New Bedford  
514.1  
ESD

**DECLARATION FOR THE EXPLANATION OF  
SIGNIFICANT DIFFERENCES**

New Bedford Harbor Site/Hot Spot Operable Unit  
New Bedford, Massachusetts

**EXPLANATION OF SIGNIFICANT DIFFERENCES  
NEW BEDFORD HARBOR SITE/HOT SPOT OPERABLE UNIT  
NEW BEDFORD, MASSACHUSETTS**

FIGURE 2  
 CONCEPTUAL CDF COVER DESIGN

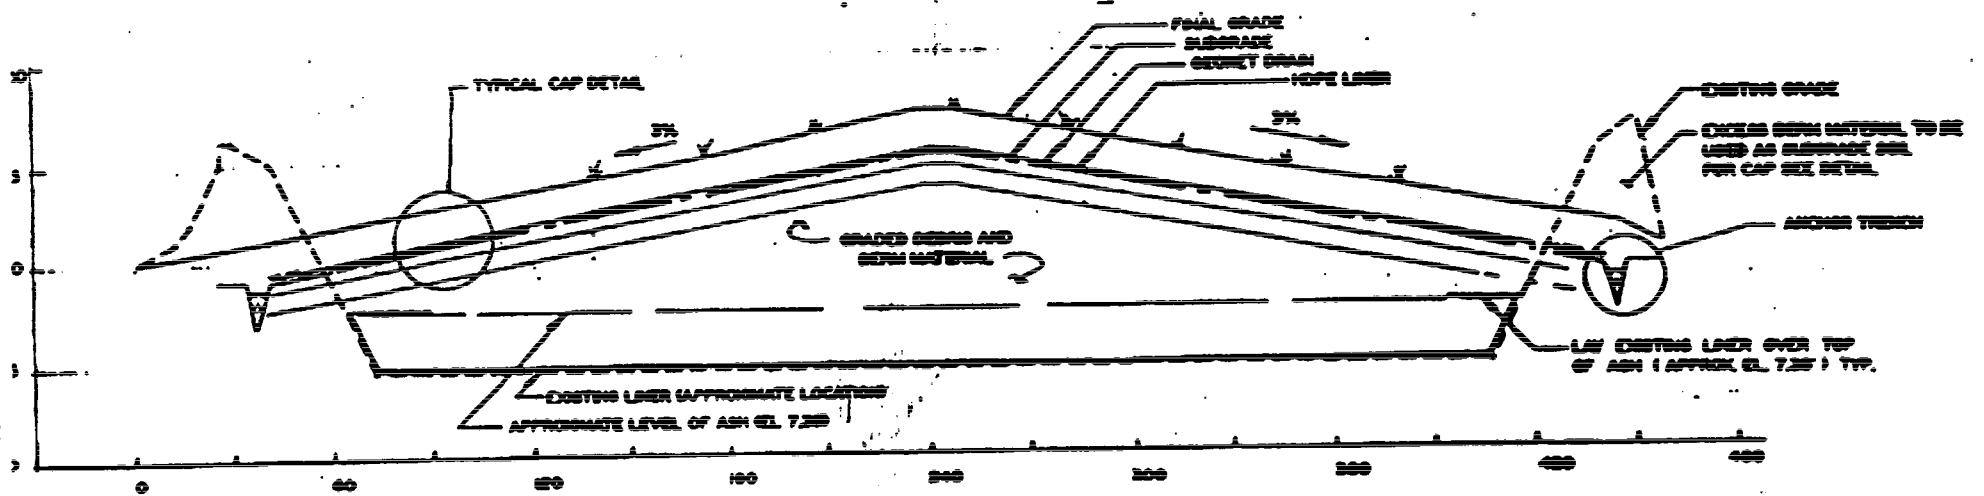
To ensure protectiveness, the CDF will be closed in accordance with the RCRA Hazardous Waste Regulations for landfills (310 CMR 30.620). The closure will consist of a bottom liner, an impermeable cover and a leachate monitoring/collection system.

The cover for the CDF is being designed to attain the final cover closure requirements for hazardous waste landfills (310 CMR 30.633). The cover system will include a bedding layer, an impermeable flexible membrane liner (with a drainage layer) and finally, a two-foot-thick soil/vegetative cover layer. See Figures 2 and 3 for conceptual design drawings.
